UNITED STATES PATENT AND TRADEMARK OFFICE

10/728,150

Office Action Summary

DETAILED ACTION

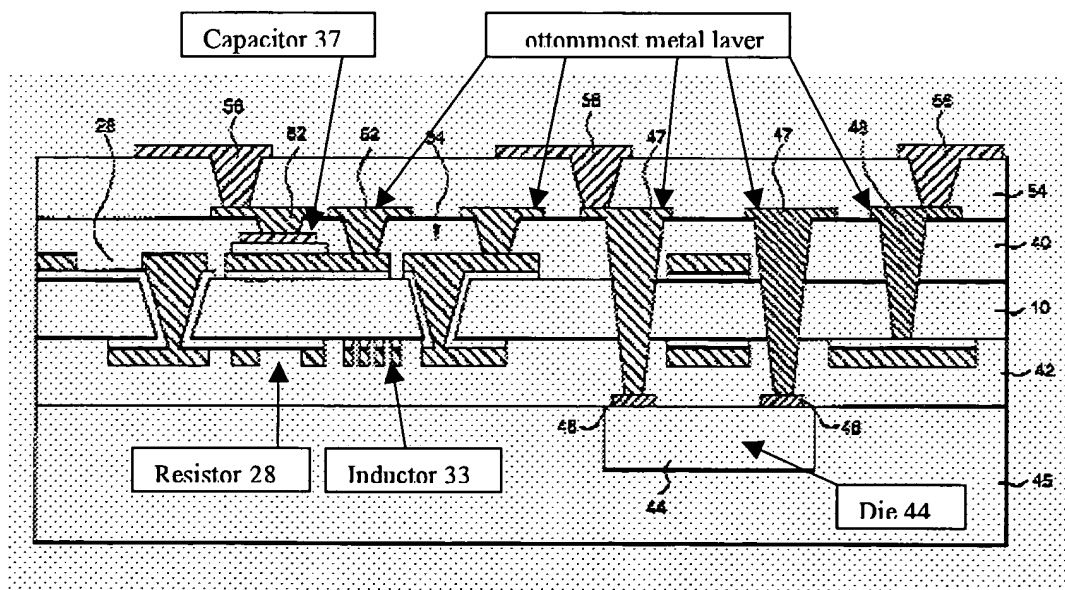
c) Applicant argues in page 12 of the Remarks that Saia reference fails to teach, hint or suggest the claimed “bottommost metal layer” and that reference numbers 47, 48, and 52 are vias. In response, the Examiner points out that Saia reference does teach (see figure 12 attached above) a metal layer (considered as the claimed “bottommost metal layer”), which is formed on the insulation layer 40 and having other portions 47-48-52 extended to chip pads 46 of die 44, interconnect area 38, and capacitor 37, respectively, see figures 7-8 and figures 11-12 attached above, Col. 7, lines 39-65) over the horizontal level and extending to a place not over the die (44); passive devices including resistor (28), capacitor (37), and inductor (33) electrically connected to the integrated circuit die (see figures 7 and 12, Col. 6, lines 30-64). Noted that Saia et al. also disclose the method of forming the metallization layers on each of insulation layers and the metallization layers have portions extending through the vias to coupled the other metallization layers, other passive devices and die (Col. 4, line 58 to Col. 8, line 18).
